CONSERVATION COMMISSION DETAILED AGENDA

Date: March 9, 2023

2. 68 Paradise Lane –NOI – Raze and rebuild of a lakefront home – DEP File #300-1155

- Representative has requested a continuation.
5. Staff Recommendations: Continue to next meeting as requested. Next meeting is March 30th.
6. **Lot 3, 20 Fiske Hill Road & 30 Main Street (Future Road named Berry Farm) – NOI-Construction of a 68 lot manufactured housing community-DEP File# 300-xxxx**

OVERALL LAYOUT /
 KEY PLAN
 SHEET C6 of 31

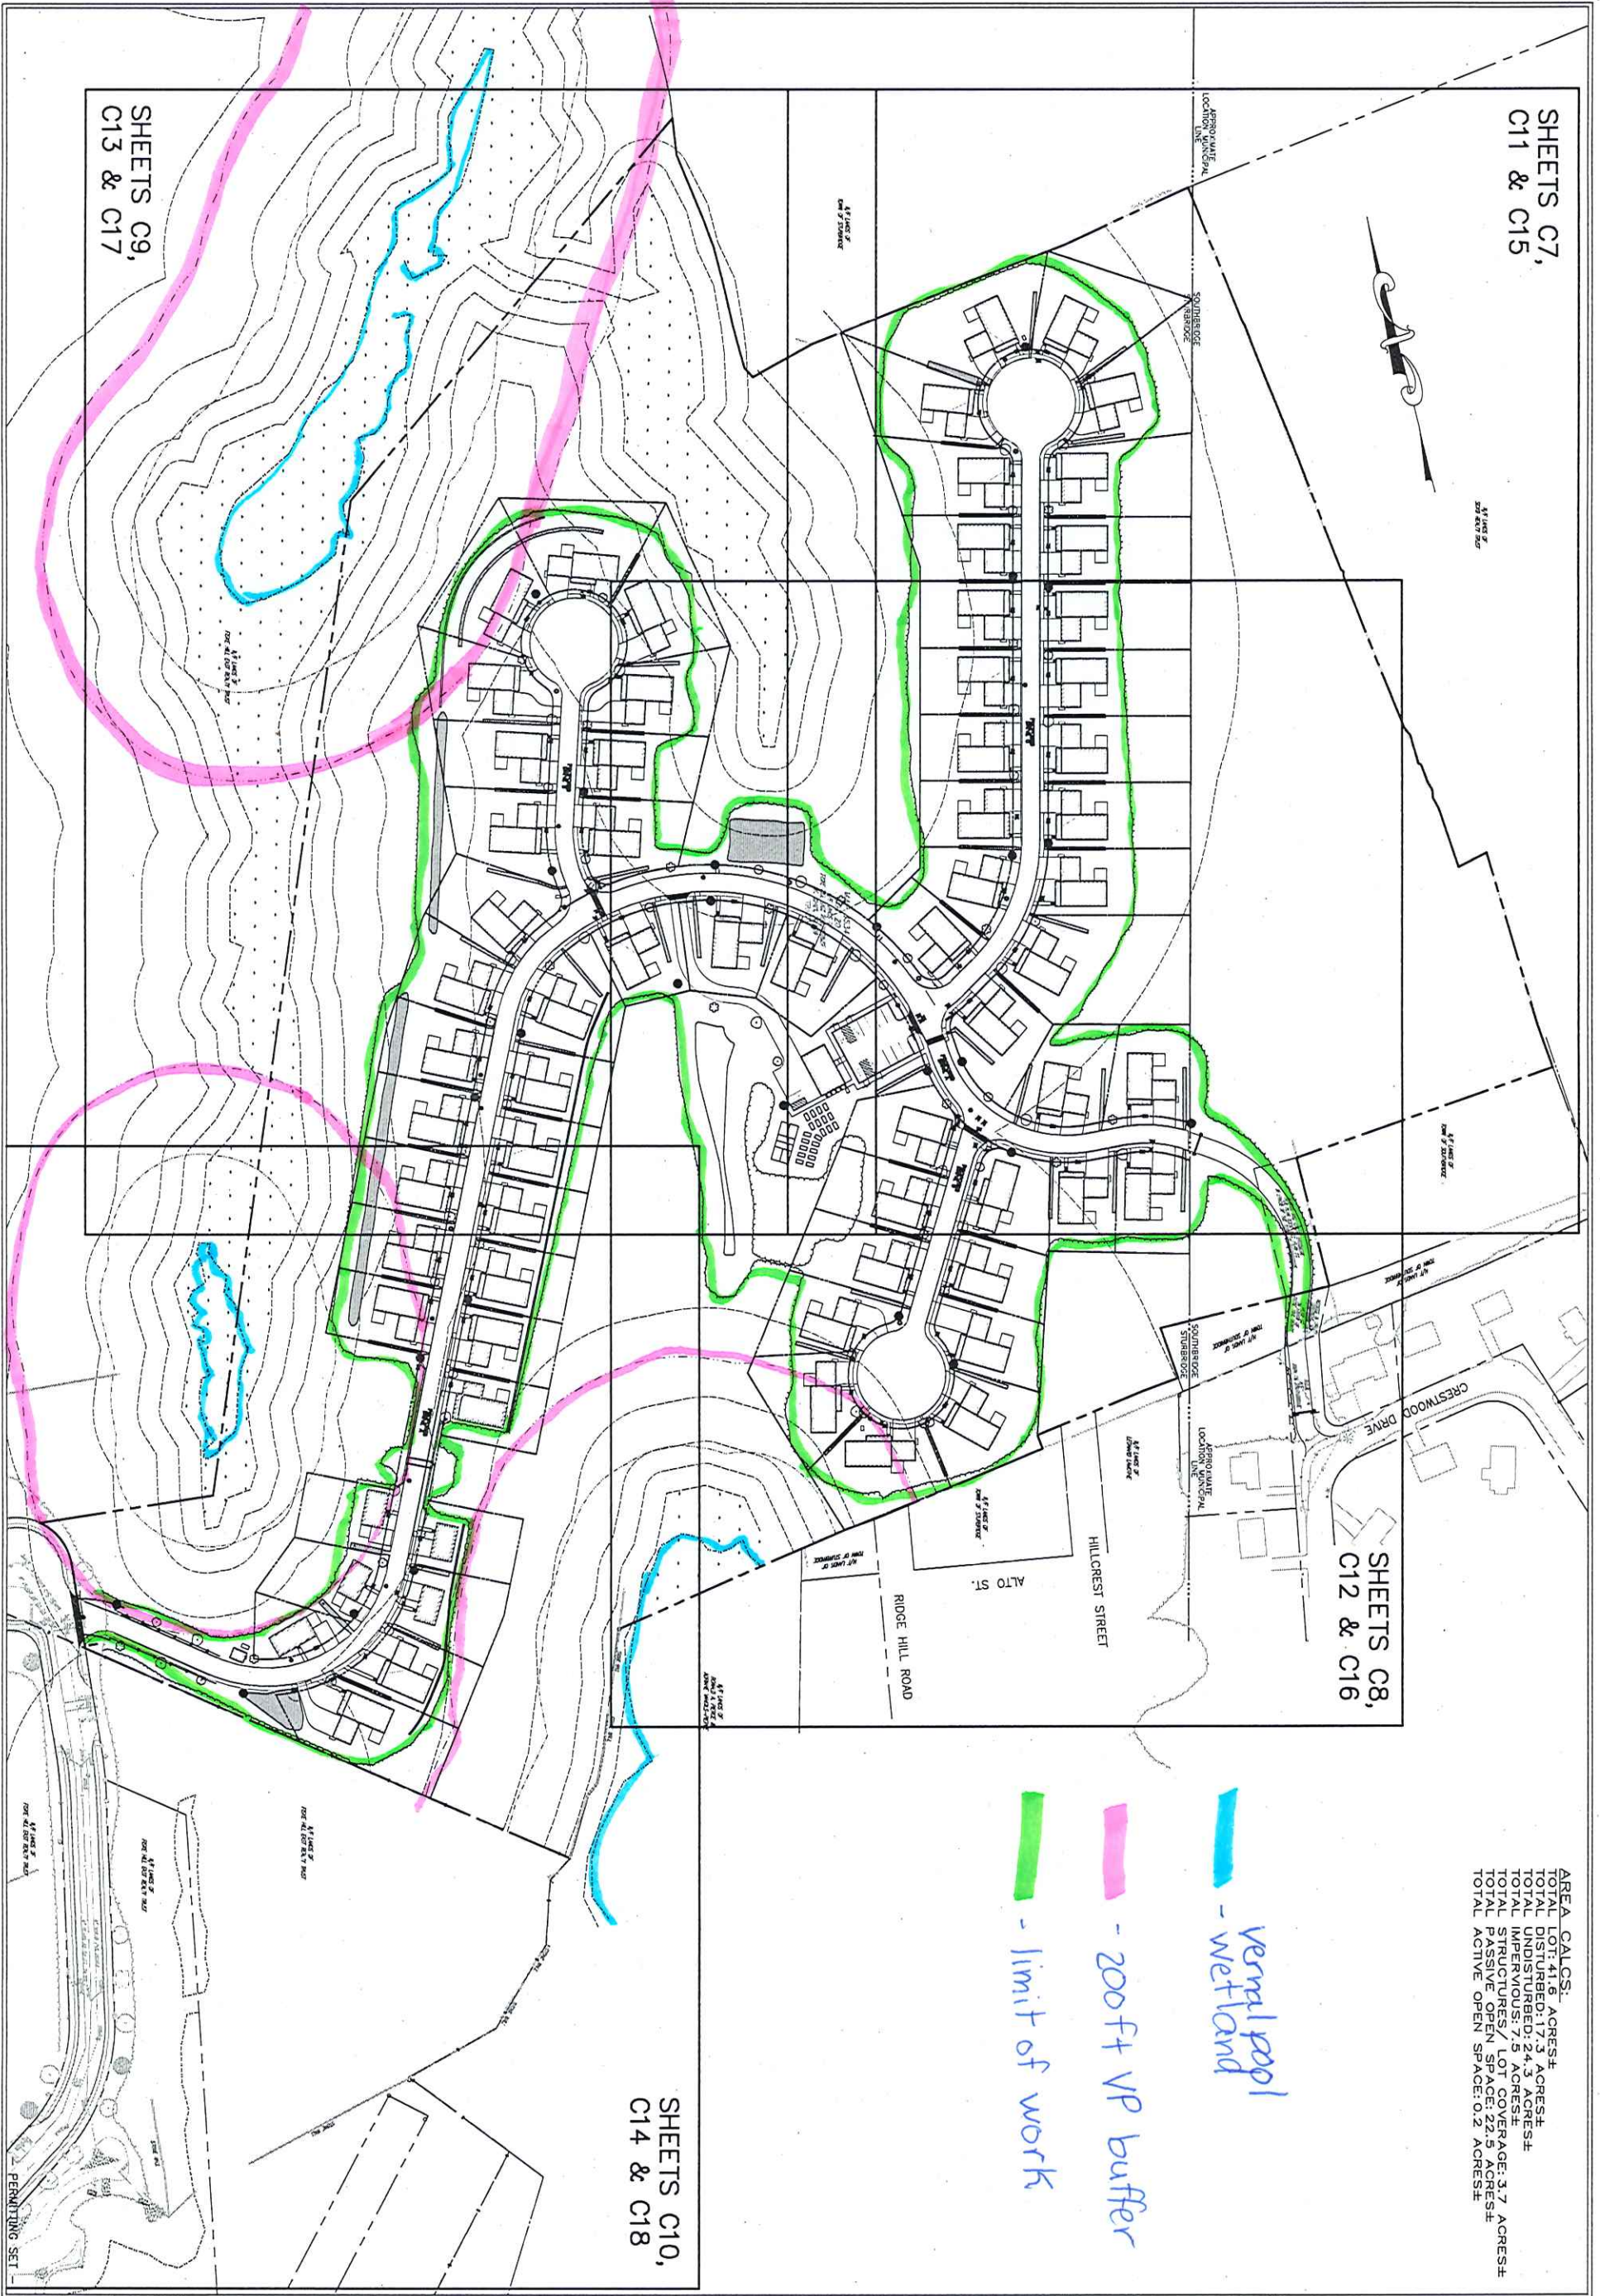
- See Attachment 3 of this agenda, for a colored plan which outlines the vernal pool buffer zones. Work has been cited outside of the 100 foot VP BZ but is located within the 200 foot VP BZ. Please note that the boundaries of the vernal pool do not coincide with the boundaries of the bordering vegetated wetlands. They are smaller in size. This was established and agreed upon by peer reviewers.
